COACHMEN RV GROUP

RE: Safety Recall 07V-539

The following is a service bulletin for incorrectly plugged leads in the slideout ignition over ride amp connector on 2008 model year Freelanders 3130, Maverick 313, and Freedom Express 31 Class C Mini Motorhomes.

BLACK PLASTIC COVER INSIDE
SECOND TRUNK BOX DRIVER SIDE

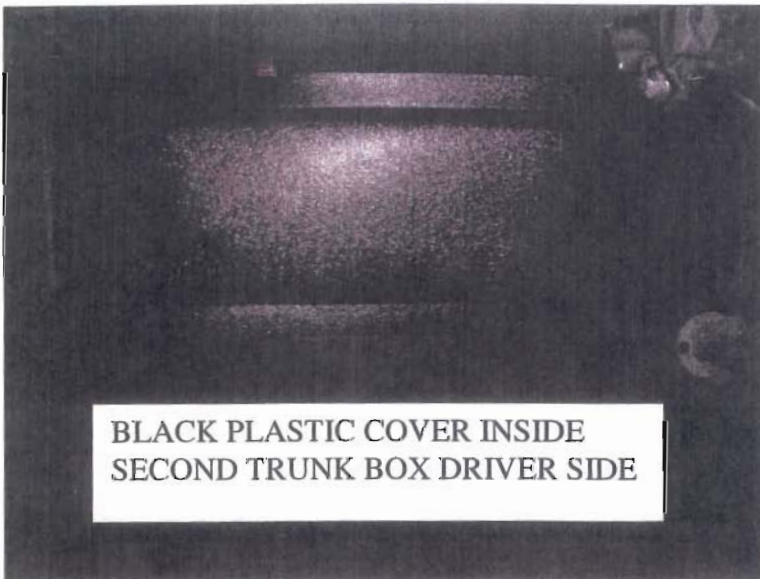
The electrical amp connector is located on the driver side, inside of the second trunk box behind a black plastic cover attached with 4-6 screws.

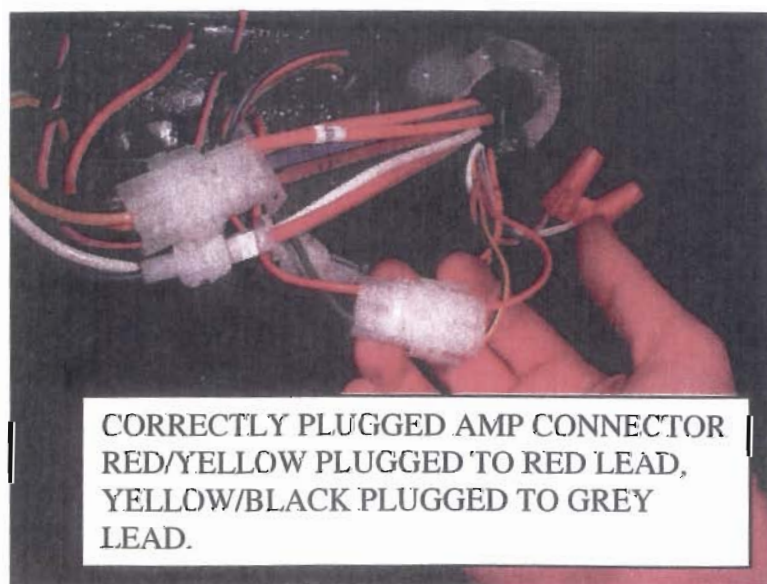
- A. If wired correctly, you will have a red/yellow lead coming from the harness plugging into a red lead from the module and a yellow/black lead from the harness plugging into a grey lead from the module. If unit is plugged correctly, no repair is required. Replace plastic cover.

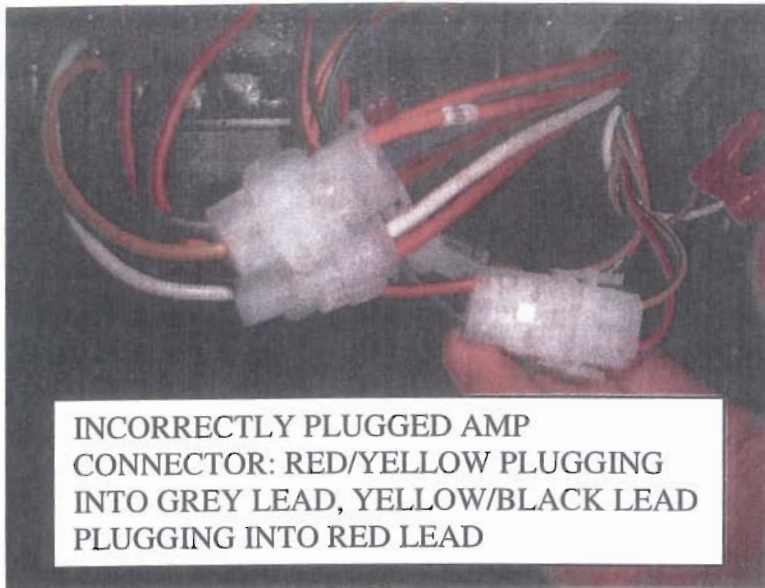
- B. If wired incorrectly, you will have yellow/black lead from the harness plugging into a red lead from the module and a red/yellow lead from the harness plugging into a grey lead from the module.

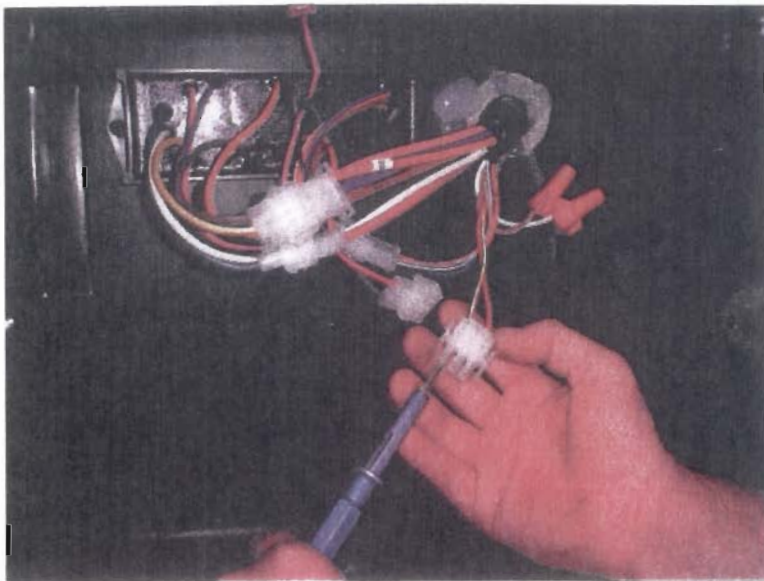
1. Separate the amp connectors.
2. Remove the lead from the harness amp connector using the de-pinning tool.

3. Re-plug the amp connector making sure you match the red/yellow lead from the harness to the red lead from the module and the yellow/black lead from the harness to the grey lead from the module.
